**RE: National Construction Code (NCC) 2022 Volume One Section J
Part J4 Statement of Compliance**

SUBJECT PREMISE: UNITING CHARLESTOWN | 27 TIRAL STREET, CHARLESTOWN NSW 2290

Attachment B – Building Fabric Requirements Markups

DRAWING TITLE: **BUILDING A - LOWER GROUND FLOOR PLAN**

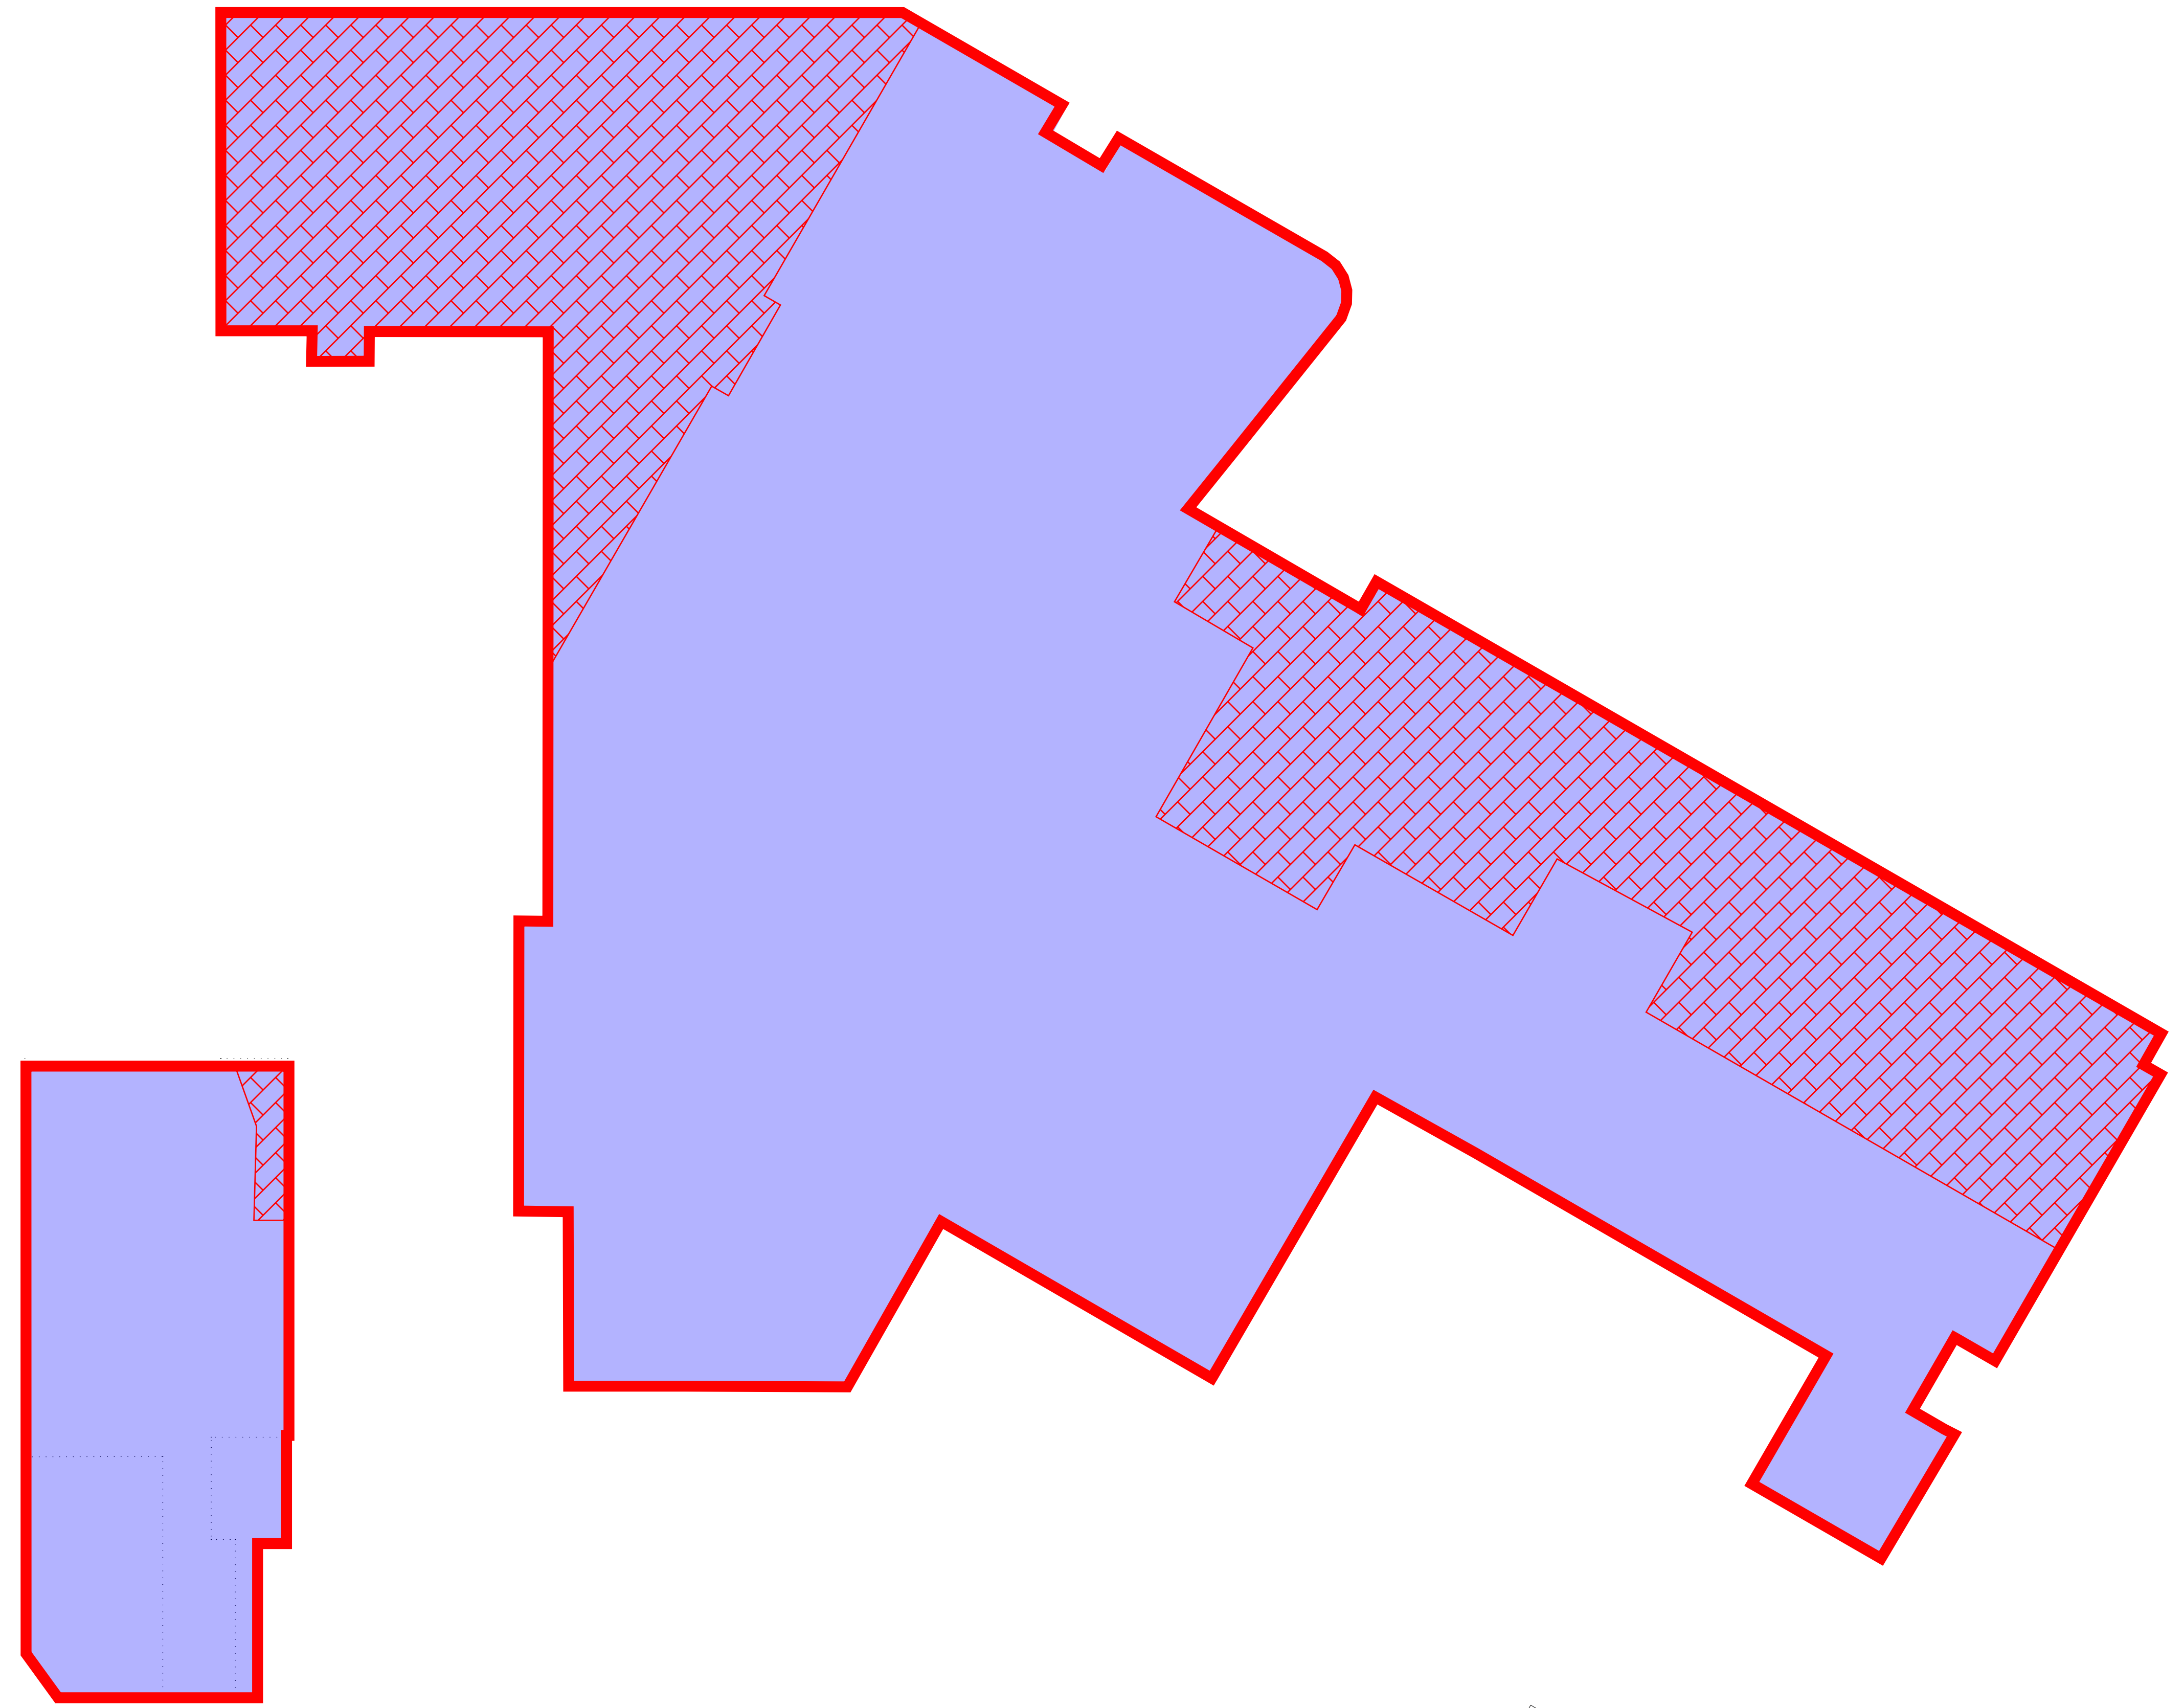
NCC 2022 Section J4 DTS requirements
 Building Fabric Required total system R-Values

▨ Roof & Ceiling - R_t 3.7 (DOWNWARDS, SOLAR ABSORPTANCE OF THE UPPER SURFACE OF A ROOF MUST NOT BE MORE THAN 0.45)
▨ Walls - R_t 1.4
▨ Floors (including Slab on Ground) - R_t 2.0

Note:
 1) The R-value is a total system performance value and NOT insulation.
 2) The above construction are only to be applied to non-glazed portions of the envelope and spandrel panels; glazing must be installed as per the architectural layouts with its thermal performances pursuant to the respective glazing specifications stated in the Section J report.
 4) For Climate Zone 5, a slab-on-ground floor that does not have an in-slab heating or cooling system is considered to achieve a total R-value of R2.0.

DTS Glazing (Glass + Frame) requirements:
 All Windows - U-value: 4.5, SHGC: 0.38 (Single Glazed Low E Tinted or the like)
